STATE OF FLORIDA  
DEPARTMENT OF HEALTH  
ONSITE SEWAGE TREATMENT AND DISPOSAL  
SYSTEM  
APPLICATION FOR CONSTRUCTION PERMIT

STATE OF FLORIDA  
DEPARTMENT OF HEALTH  
ONSITE SEWAGE TREATMENT AND DISPOSAL SYSTEM  
SITE EVALUATION AND SYSTEM SPECIFICATIONS

STATE OF FLORIDA  
DEPARTMENT OF HEALTH  
ONSITE SEWAGE TREATMENT AND DISPOSAL  
SYSTEM

CONSTRUCTION PERMIT FOR: OSTDS Repair  
APPLICANT: (Alachua County Housing Authority Lot 3)  
PROPERTY ADDRESS: 13555 SW 156th Ter Archer, FL 32618  
LOT: 3 BLOCK: NA SUBDIVISION: Thistle Hills East  
PROPERTY ID #: 04974-003-000 [SECTION, TOWNSHIP, RANGE, PARCEL NUMBER]  
[OR TAX ID NUMBER]

05-310-18

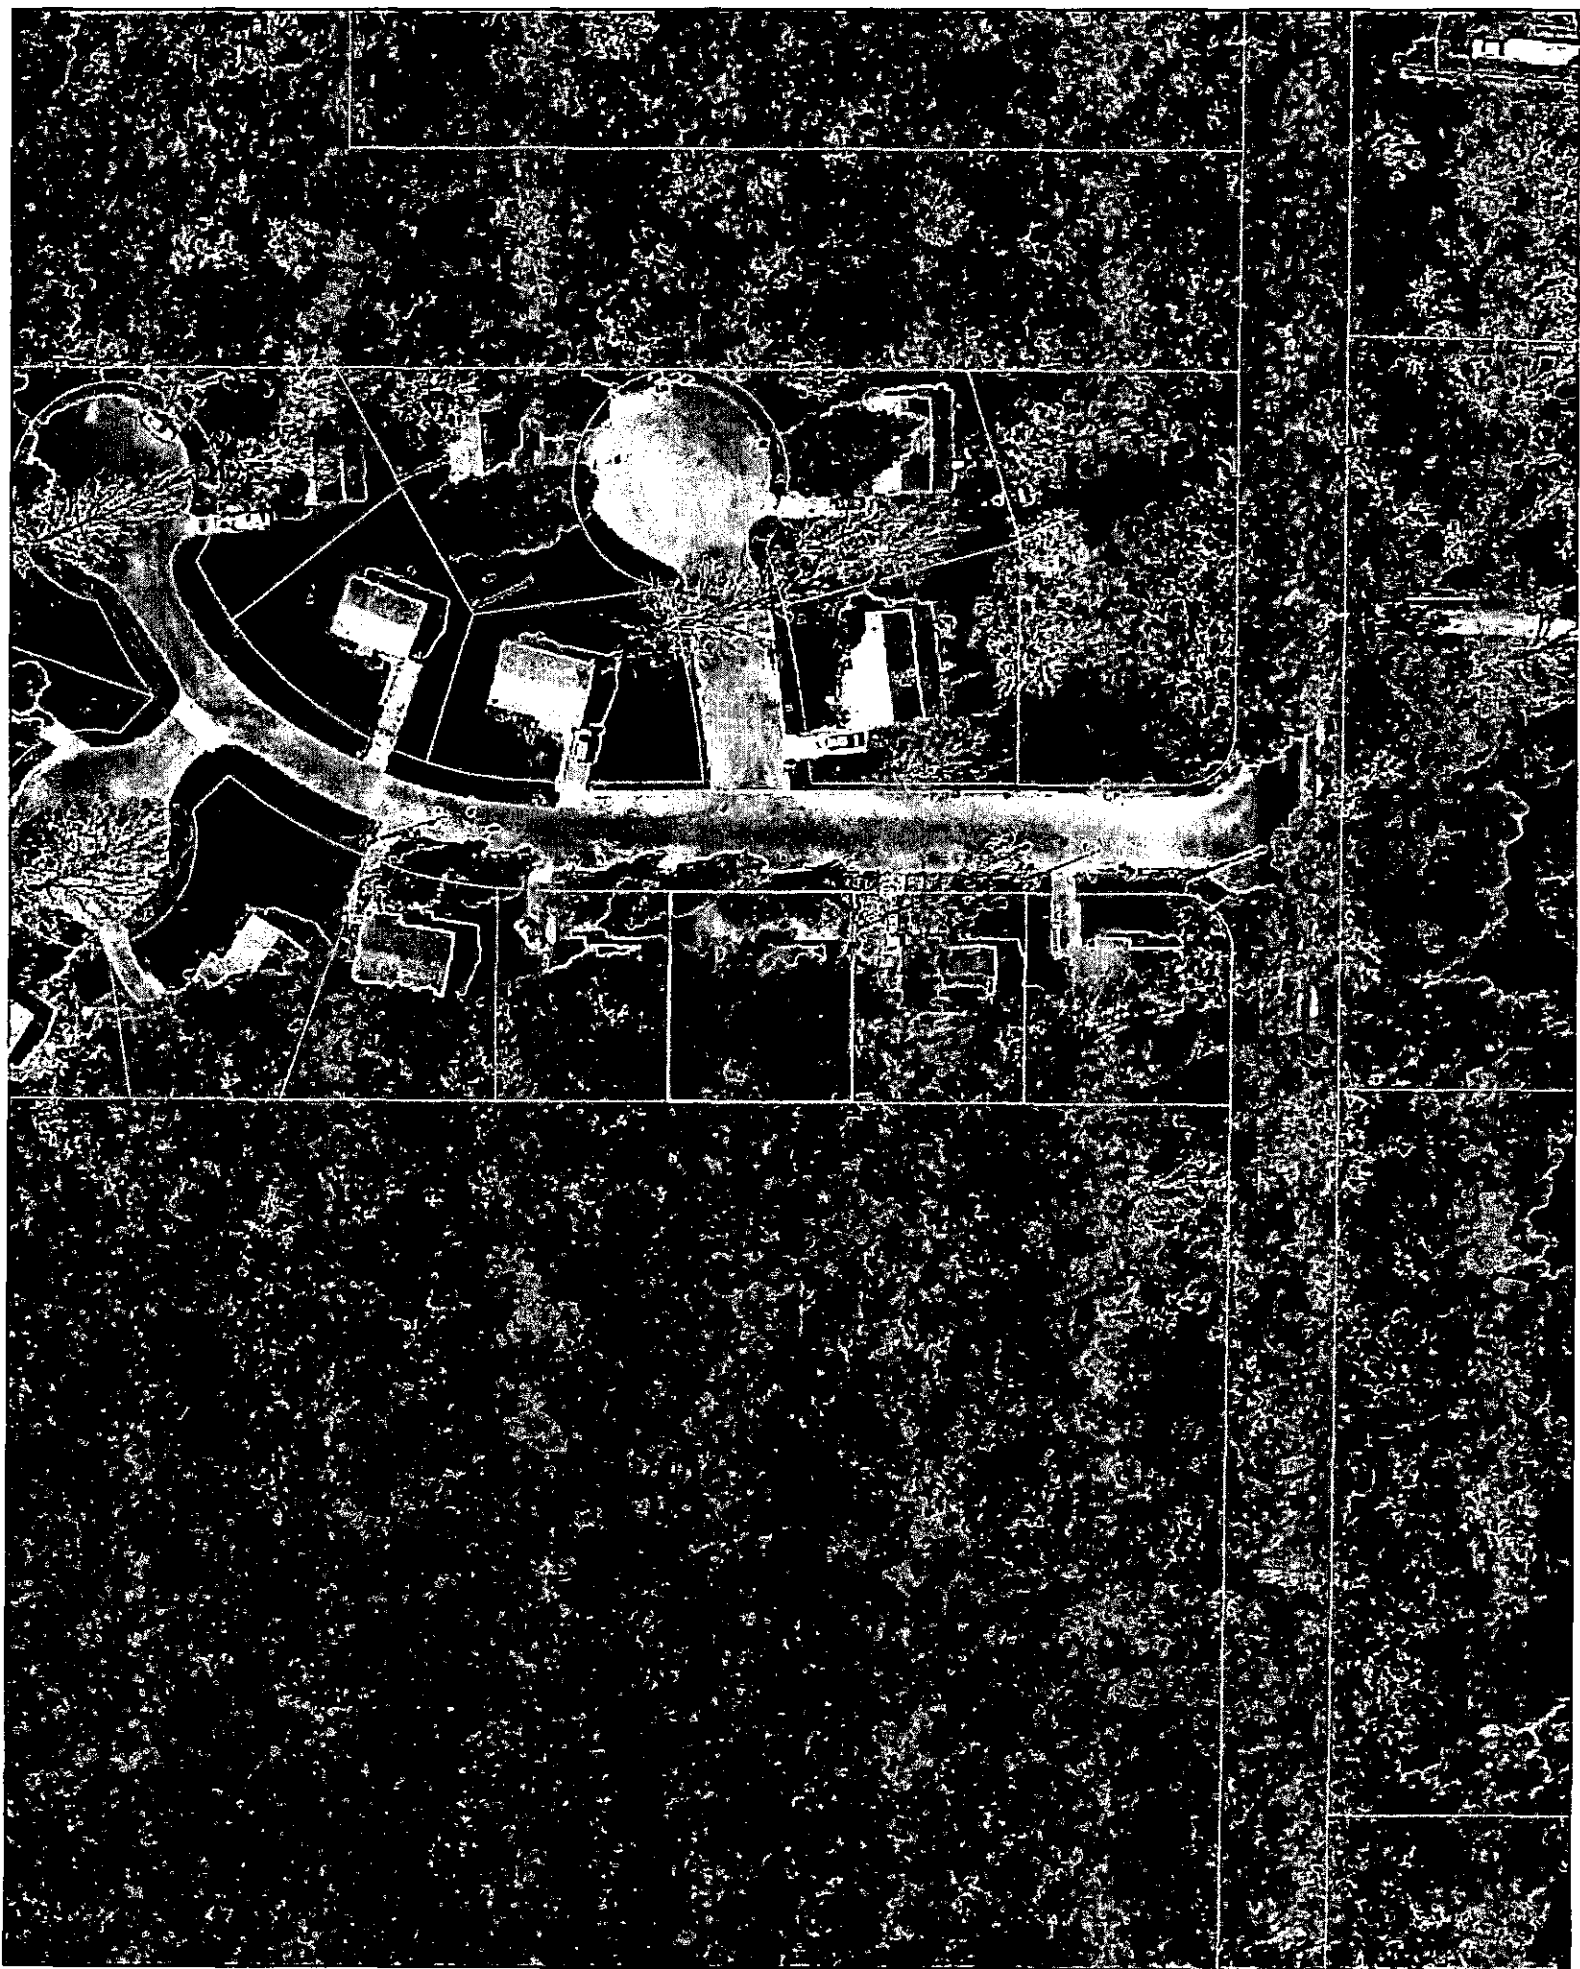
Can you please clarify the 20" mottling depth listed on the attached site evaluation for 13555 SW 156<sup>th</sup> Ter.? If the mottling is associated with a water table please describe the mottles in the soil profiles in contrast and prevalence; otherwise this may need to be revised on the form as this field is specifically for high chroma indicators indicative of wetness. Guess we just need clarification if the profiles are indicative of a polychromatic matrix or if it is high chroma redoximorphic features.

Just a polychromatic matrix. Not redoximorphic feature.  
If you need anything else please let me know.
